DONALD C. COOK NUCLEAR PLANT, UNIT NO. 1

AMENDMENT TO FACILITY OPERATING LICENSE

Amendment No. 25
License No. DPR-58

ATTACHMENT TO LICENSE AMENDMENT NO.

Figure 3.2-3a
 Exposure Dependent F_O^L Limit, $F_O^L(E)$, and Normalized Limit $T(E)$ as a Function of Peak Pellet Burnup for Exxon Nuclear Company Fuel.

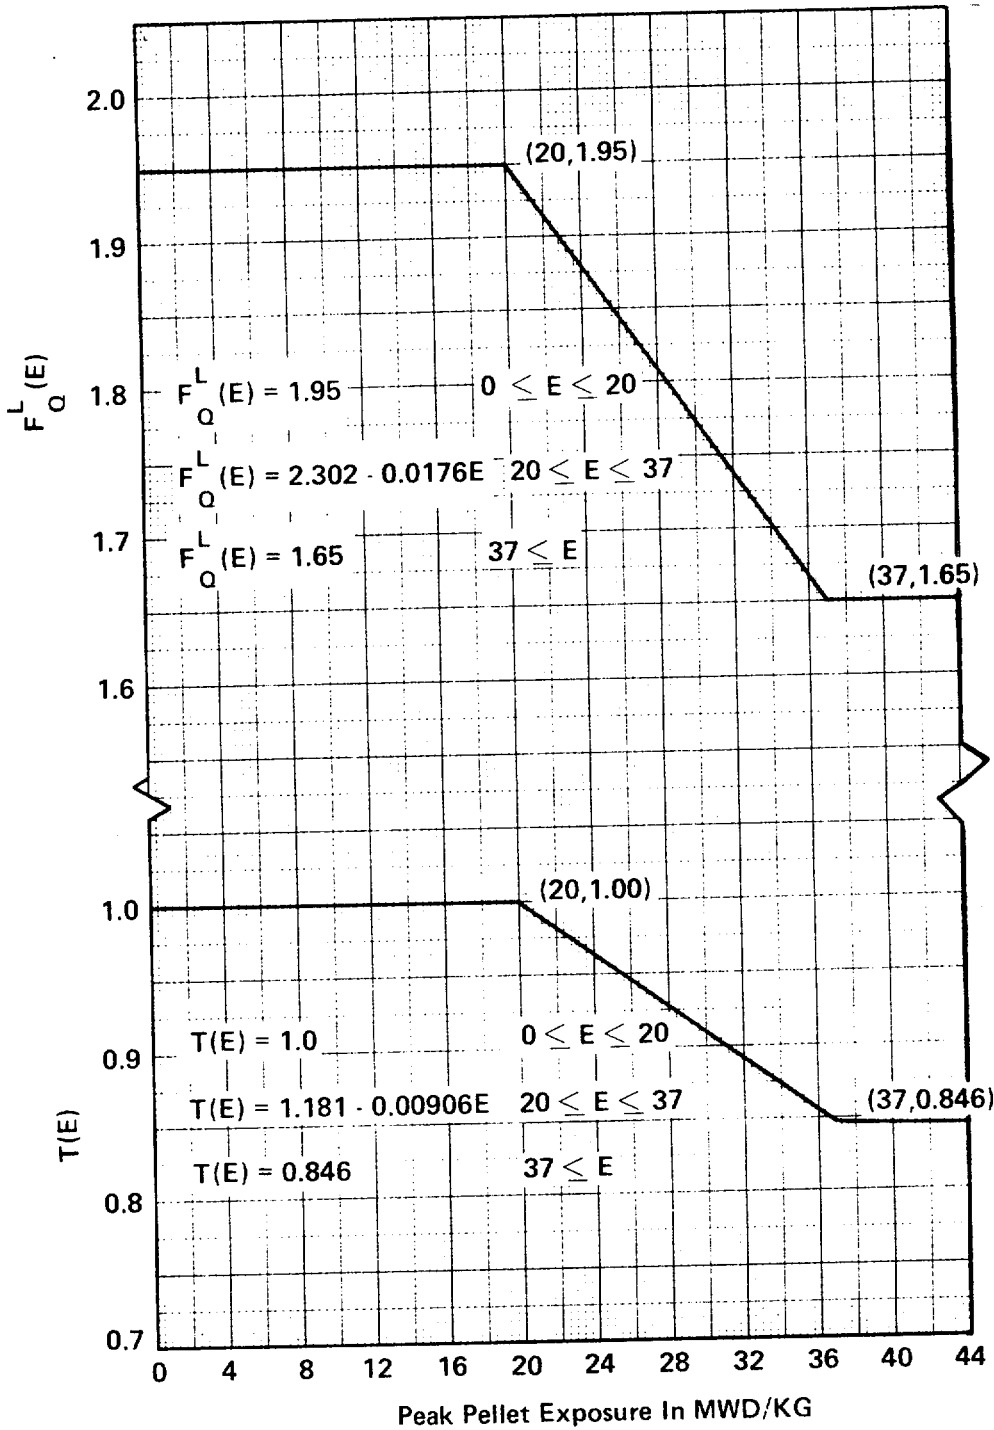
$F_Q^L(E_\ell)$ is the exposure dependent F_Q limit for rod ℓ and is defined on Figure 3.2-3a for Exxon Nuclear fuel, Figure 3.2-3b for Westinghouse fuel and page 3/4 2-15. E_ℓ is the maximum pellet exposure in assembly ℓ . $K(Z)$ is the function obtained from Figure 3.2-2 for a given core height location. F_Q is defined as the $F_Q(Z, \ell)$ with the smallest margin or the greatest excess of the limit.

By application dated February 3, 1978, supplemented by letter dated April 17, 1978, the licensee proposed Technical Specification changes to Facility Operating License No. DPR-58 for the D. C. Cook Nuclear Plant, Unit No. 1. The changes would modify existing calculational techniques for the fuel exposure dependent heat flux hot channel factor (F_Q) and the allowable fuel exposure. The bases are contained in Exxon Nuclear Company (ENC) Document XN-NP-76-51, WREM-Based Generic PWR ECCS Evaluation Model ENC-WREM-II, Supplements 1 through 4.

Figure 3.2 - 3b

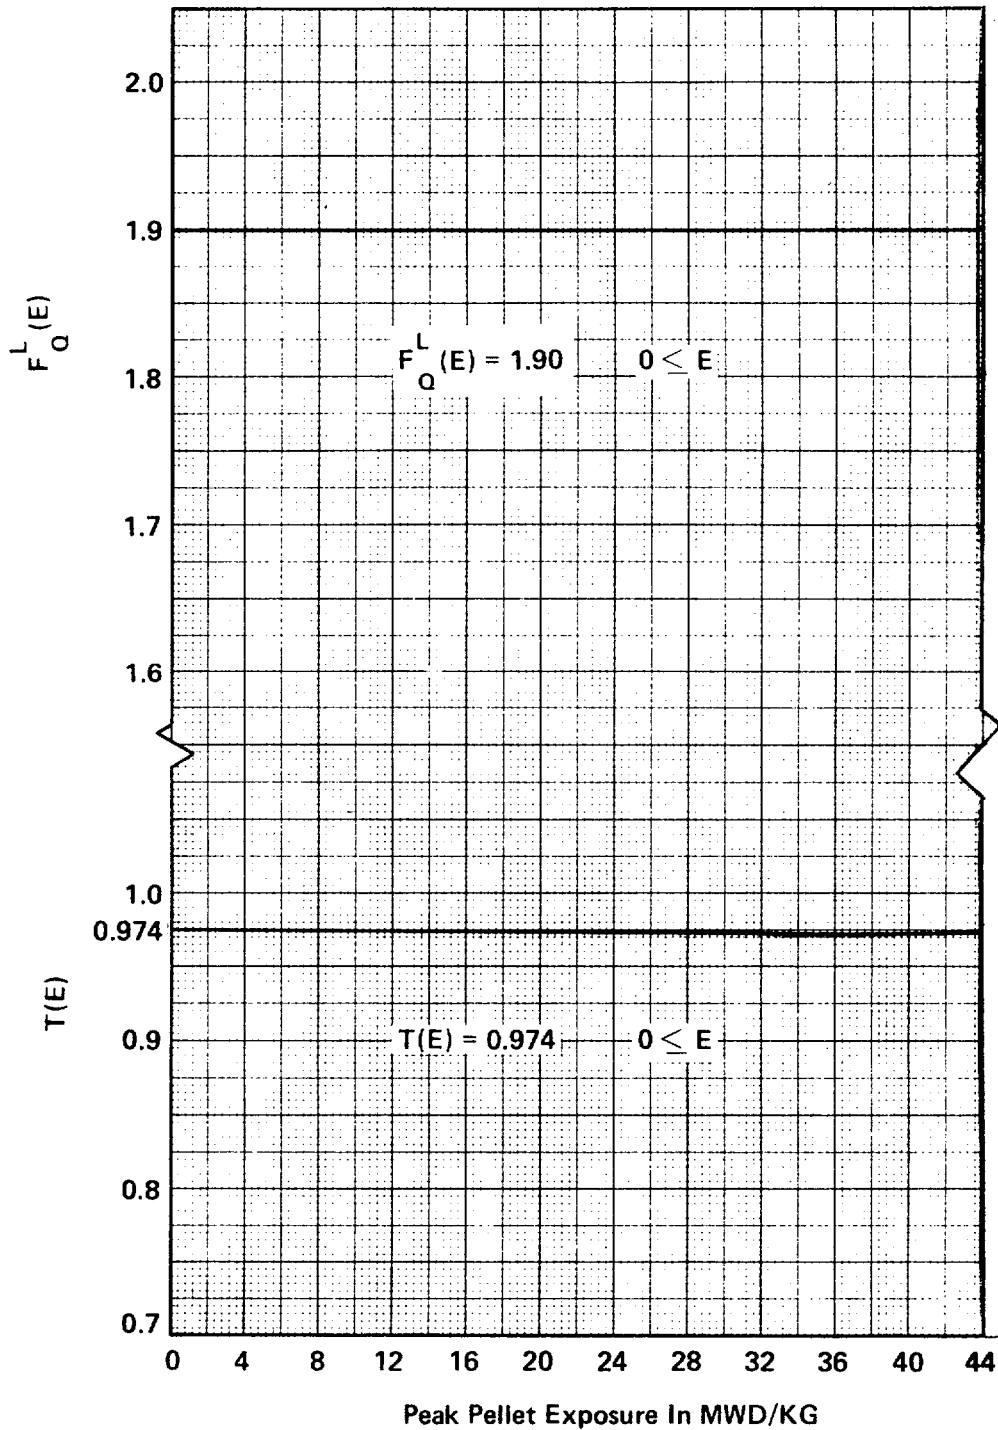
In addition, the heat flux hot channel factor limit for Westinghouse Electric Corporation fuel has been modified in accordance with the Commission's exemption issued on May 10, 1978. We have also included a specification change relating to initial implementation of certain fire protection surveillance activities which we inadvertently left out of License Amendment No. 22 dated December 12, 1977. This change as well as other minor changes made to your proposals have been discussed with and agreed to by your staff.

In the April 17, 1978 letter, the licensees' also proposed interim limits on F_0 for Westinghouse Electric Corporation fuels still remaining in the core. These limits were necessary due to the recently discovered Zirconium-water reaction calculational error reported by Westinghouse to the NRC staff by letter dated April 7, 1978. The Commission has issued an exemption dated May 18, 1978, which permits operation with the F_0 limit which has only been added in Technical Specification Figure 3.2-3b. The safety evaluation is a part of the exemption package.
